SUPPLEMENT TO NARRATIVE
LINCOLN WOODS DEFINITIVE SUBDIVISION PLAN
435-439 LINCOLN STREET, LEXINGTON, MA

February 24, 2016

The following information is a summary of the Plan & Specification modifications the development team has made in response to Planning Board and Staff comments and recommendations at the Planning Board's initial Definitive Hearing on this project on January 20, 2016. This summary is to be read as a supplement to the initial Narrative Description which was filed with the Board prior to our January 20th meeting.

TURNING RADIUS STUDY &
 HYDRANT LOCATION PLAN
 LINCOLN WOODS
 SCALE: 1"=40'
 DATE: 2-3-16

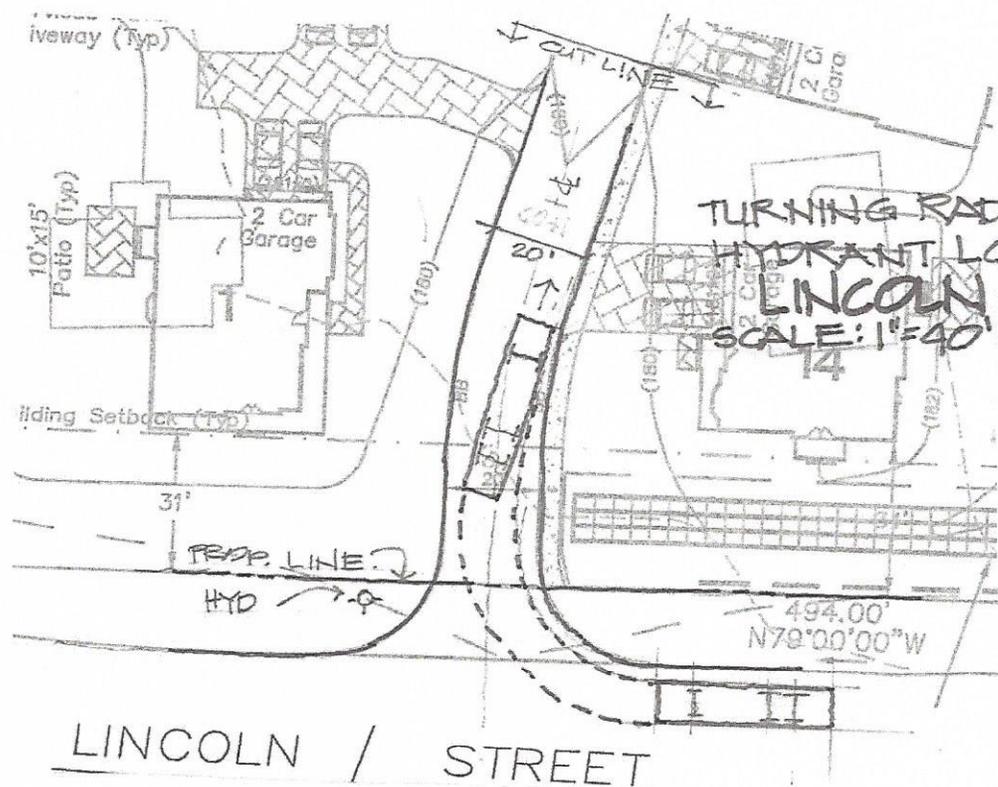
The common driveway will be 20 ft. in width to the pear shaped cul-de-sac. The pavement width around the cul-de-sac will be 25 ft. The diameter of the outside curb is 100 ft. A 'cape cod berm' is proposed as curbing with a 4 ft. wide sidewalk abutting the curb providing a total continuous paved diameter of over 109 ft. The island is defined by a curb 50 ft. in diameter with the curb set back an additional 4 ft. to provide for two parallel parking spaces on each side, for a total of four guest parking spaces. Parking in this location will not interfere with emergency vehicle access. (See attached sketch). The minimum turning radius for the large ladder truck is 42 ft., which will easily be accommodated by the proposed common driveway.

Attached is a sketch showing the ladder truck with a minimum turning radius at the end of the cul-de-sac and at the common driveway entrance at Lincoln St. Circulation at both locations is easily accomplished.
